Delegated Report

Date: 17th March 2022

Subject: Melrose Avenue-Review & modification of existing contra-flow cycle lane

MELROSE AVENUE- CONTRA-FLOW CYCLE LANE IMPROVEMENTS

Scheme drawing Merton Traffic and Highways 'General Layout 2022'

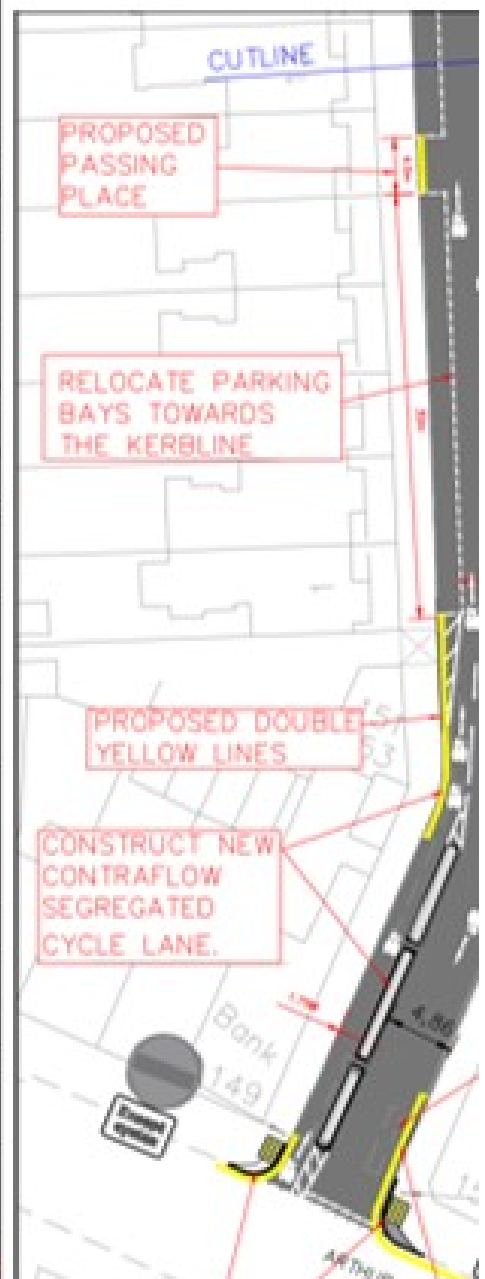
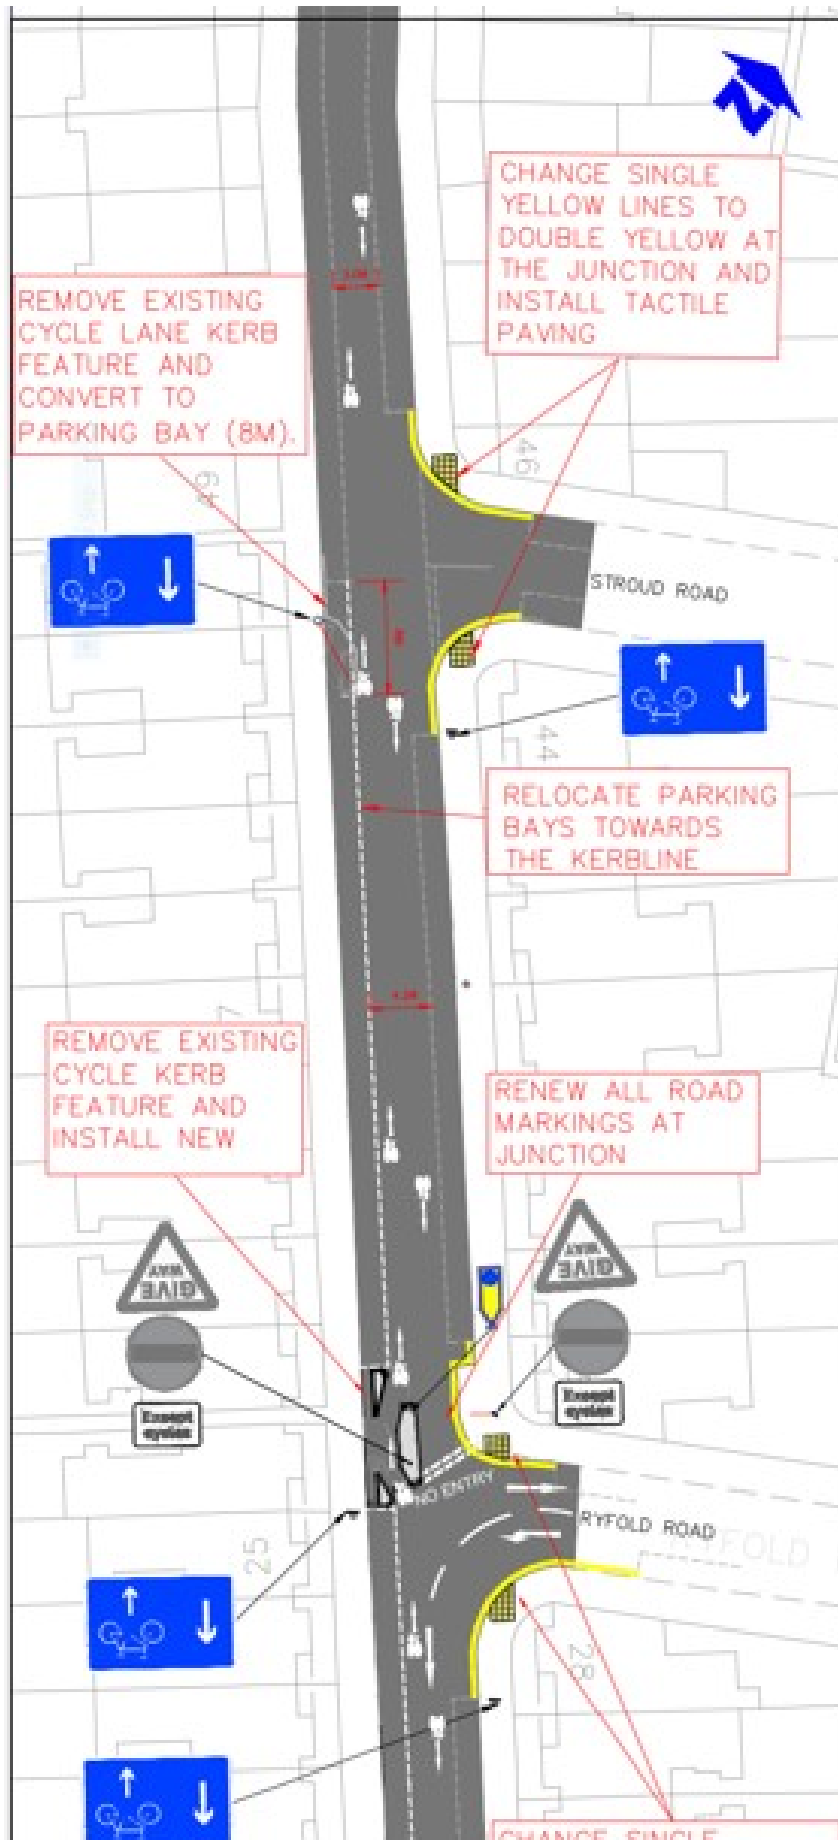
If the junction is being re-kerbed at the Arthur Rd end then the 4.86m wide space for drivers on the proposal could be much reduced and the footway should be made continuous to provide priority for people walking straight ahead as per this junction below.

We estimate that a minimum of 1 in 10 of the parking places needs to be removed to make these breaks. Without the breaks cyclists will experience extreme discomfort being relentlessly squeezed against the flow of motor vehicles. It is therefore without question that the current proposal is not an improvement and might only

The previous 2019 statement quotes the London Cycling Design Standards (LCDS) 'golden rule': that traffic lanes restricted to dimensions between 3.2 and 3.9 metres should be avoided, because of the discomfort it causes cyclists moving together with motor vehicles. This has now been revised in the latest LCDS to a width between 3.2 and 4 metres. It perhaps can be understood why passing places must be introduced in Melrose Avenue by removing some car parking if contra-flow cycling without a dedicated lane is proposed and why any change to the existing situation without strategic removal of car parking makes cycling considerably more intimidating.

4.3 The DMRB GG/119 item 5.3 states that the needs of all road users shall be assessed when undertaking the RSA. Even though this case is primarily concerning a change to a cycling facility there is no indication that the auditors have made a point of assessing the needs of cyclists except at the Arthur Road start to the contra-flow when the 'protected' cycling section terminates. This has accordingly been amended in the present proposal. However the 'exacerbation of the problem' that the auditors refer to in their item 2.10 is the width of the carriageway at this location (although they confirm the carriageway width is constant). The auditors are admitting to reservations about the general width of the carriageway for cycling but these are not given any attention in their report.

4.5 A contributory factor to the Auditors' misjudgement of 'improvements' may be due to their interpretation of the brief in the Road Safety Audit Report item 1.9 where they interpret the proposal to be that the 'existing contra flow cycle lane' will be 'revised in order to run to the east of the parking bays on the western side of Melrose Avenue'. The Road Safety Audit appears to be based on the assumption that there will be a dedicated cycle lane as a contra-flow, which is not the case. If this is the basis for their findings then it suggests that the 'contra-flow cycle lane' should stay where it is.
